**Town of Kittery
Planning Board Meeting
February 9, 2023**

ITEM 2 – 39 Badgers Island, Sketch Plan Review – Minor Subdivision

Action: hold public hearing: Pursuant to §16.4 Land Use Regulations and §16.9.3 Shoreland Development Review requirements of the Town of Kittery Land Use and Development Code, owner applicant B.I.W. Group, LLC and agent Chris Atwood Otter Creek homes with Ambit Engineering propose to subdivide the 0.48-acre parcel identified as Lot 38 of Tax Map 1 into 4 residential condominiums. The property is located at 39 Badgers Island West, in the Mixed-Use Badgers Island Zoning District (MU-BI) and Shoreland Overlay Zone (OZ-SL-250’).

**CONDOMINIUM SITE PLAN
 39 BADGERS ISLAND WEST
 CONDOMINIUM**

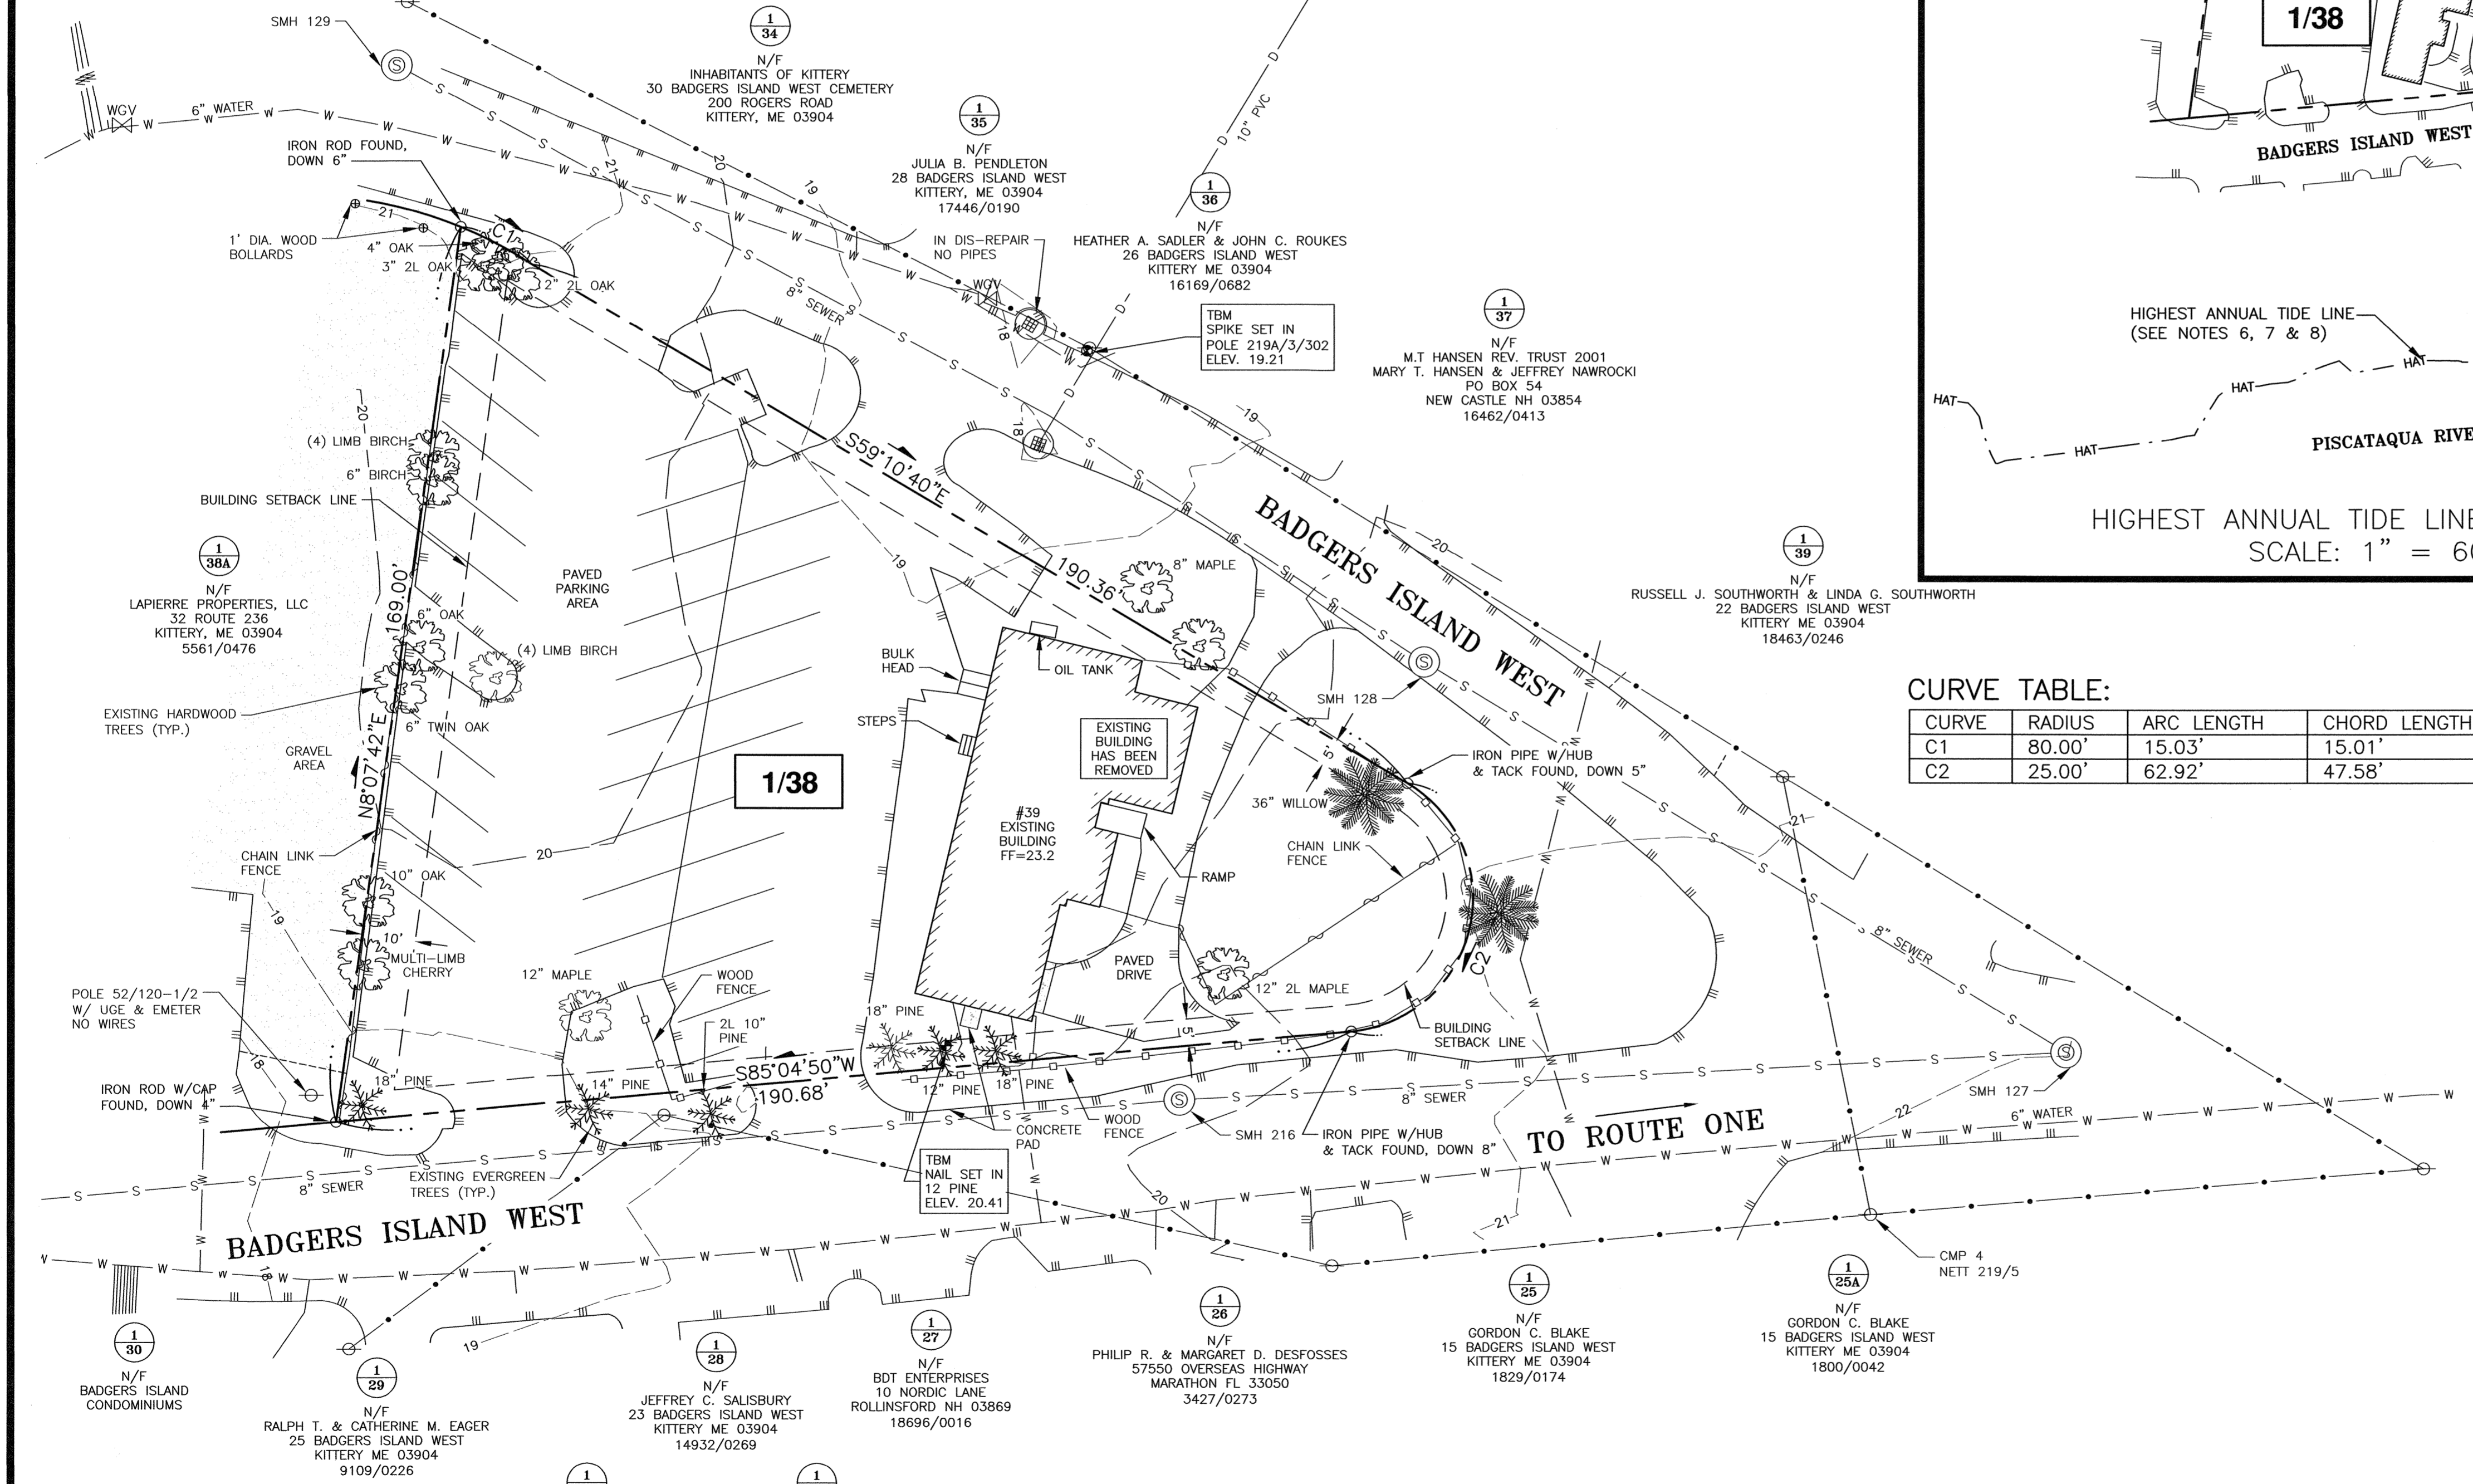
- Cover Sheet – This plan shows the design team, site location, and Legend. **Revised Date.**
- Condominium Site Plan - The plan is the plan that will be recorded for the creation of the Condominium at the site. The plan shows Common and Limited Common areas. **Revised entrance location.**

SHORELAND DEVELOPMENT PLAN

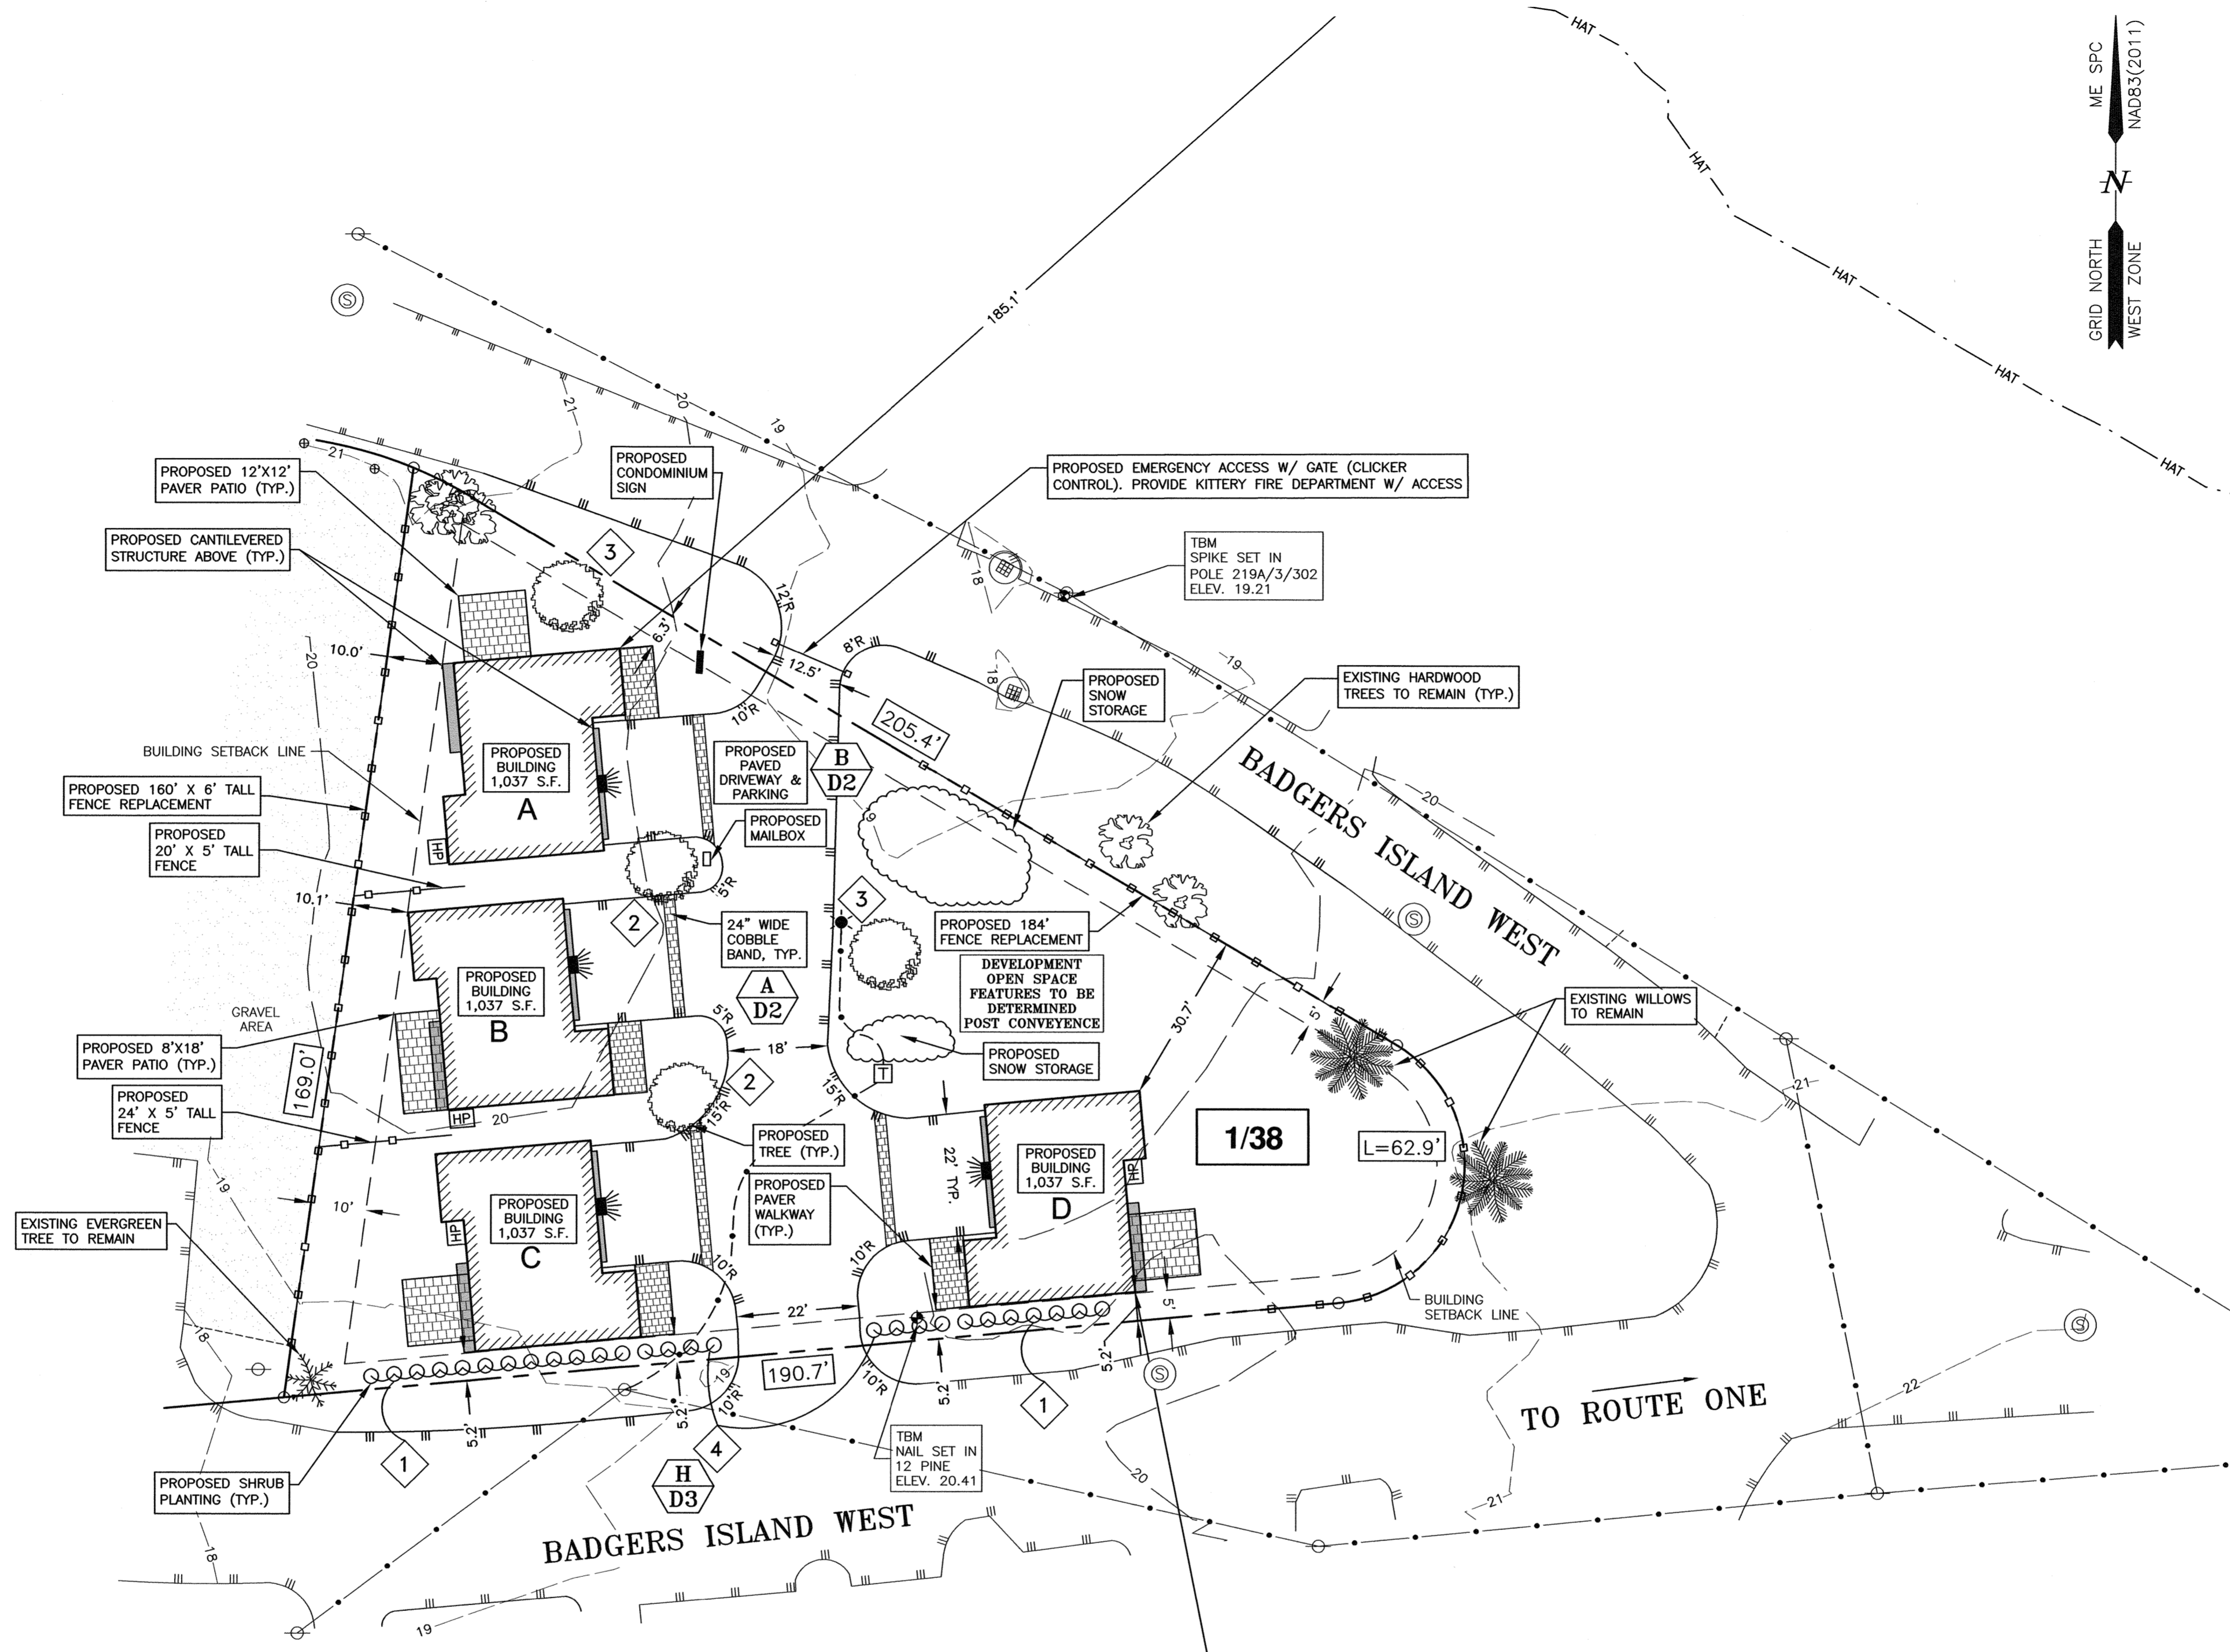
- Shoreland Development Plan C2 – This plan shows the location of the proposed buildings, landscaping, parking, patios, walkways, signage, and driveway entrance. The building siting takes advantage of available views. The plan highlights the existing landscaping (trees) that will be retained. The plan contains the Devegetated Coverage Table. **Revised entrance location, secondary exit width, Spirea plant substitution, Note 8 regarding snow storage, added automatic gate at secondary exit.**
